RC1

Specific comments

Figure 1: Quality index of the Moucherotte radar QPE (left) and Colombis radar QPE (right) over the Grandes Rousses domain. This quality index is used to weight the contribution of each single radar QPE in the final composite QPE product.

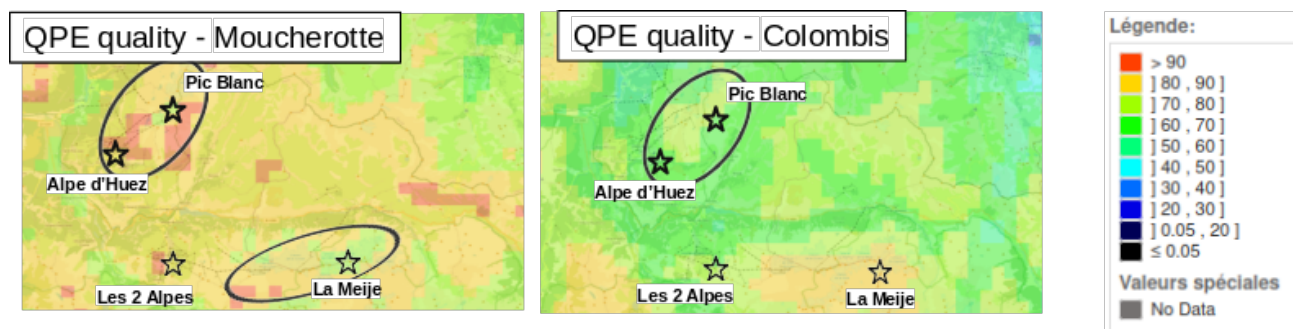
We acknowledge the challenge of disentangling the sources of error when working with a composite product, but the use of such product is necessary for large scale applications. We have based our reasoning on the assumption that the contribution of the Moucherotte radar is dominant for the estimation of precipitation over the Pic Blanc since the Colombis radar is about twice as far away from the Pic Blanc (70km) as the Moucherotte radar (37km). Figure 1 below also shows that the quality index, which is used to weight the contribution of each radar to the final product for a given situation, is higher for the Moucherotte radar than for the Colombis radar in the vicinity of Pic Blanc.

Figure 2: Relief cross section between the Colombis radar and the Pic Blanc and corresponding yearly ANTILOPE precipitation accumulation.

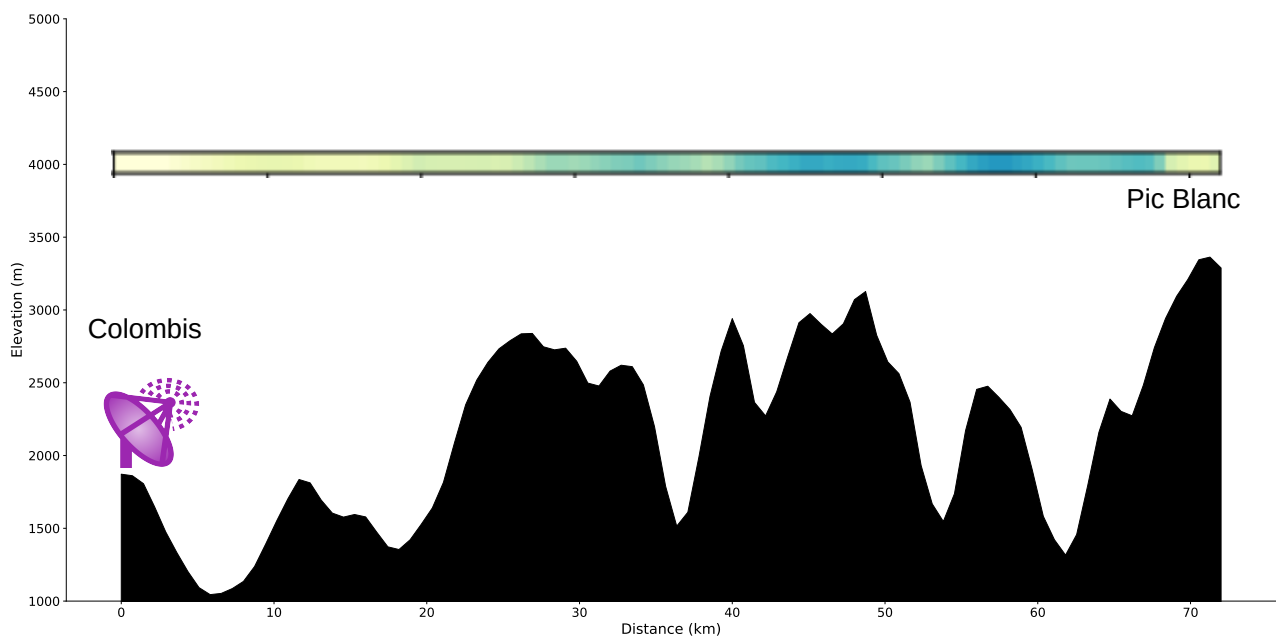
Moreover, the Colombis radar beam towards the Pic Blanc only crosses the western part of the Ecrins massif with no peaks well above 3000m as shown in Figure 2 below. This figure also confirms that the underestimation of precipitation over the Pic blanc is not due to the masking of the Colombis radar beams, since the precipitation accumulation in the valley between the Ecrins massif and the Pic Blanc (between 50km and 60km from the Colombis radar and affected by the same masks) is much higher than that over the pic Blanc (the colour scale is the same as the one in Figure 2).
